UNITED STATES PATENT AND TRADEMARK OFFICE

APPLICATION NO.	FILING DATE	FIRST NAMED INVENTOR	ATTORNEY DOCKET NO.	CONFIRMATION NO.
10/601,789	06/24/2003	Norio Kimura	2003-0865	9516

Office Action Summary

DETAILED ACTION

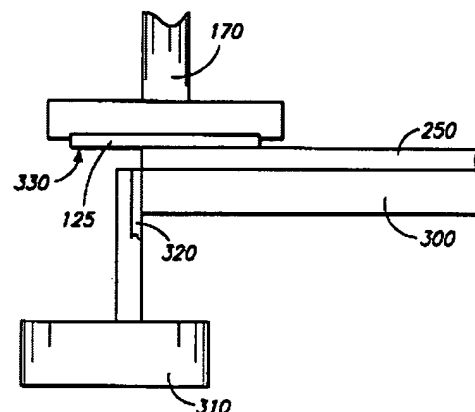
2. The drawings are objected to because in Fig. 4, electromagnetic coils 61a-64d, should be changed to 64a-64d. Corrected drawing sheets in compliance with 37 CFR 1.121(d) are required in reply to the Office action to avoid abandonment of the application. Any amended replacement drawing sheet should include all of the figures appearing on the immediate prior version of the sheet, even if only one figure is being amended. The figure or figure number of an amended drawing should not be labeled as "amended." If a drawing figure is to be canceled, the appropriate figure must be removed from the replacement sheet, and where necessary, the remaining figures must be renumbered and appropriate changes made to the brief description of the several views of the drawings for consistency. Additional replacement sheets may be necessary to show the renumbering of the remaining figures. Each drawing sheet submitted after the filing date of an application must be labeled in the top margin as either "Replacement Sheet" or "New Sheet" pursuant to 37 CFR 1.121(d). If the changes are not accepted by the examiner, the applicant will be notified and informed of any required corrective action in the next Office action. The objection to the drawings will not be held in abeyance.
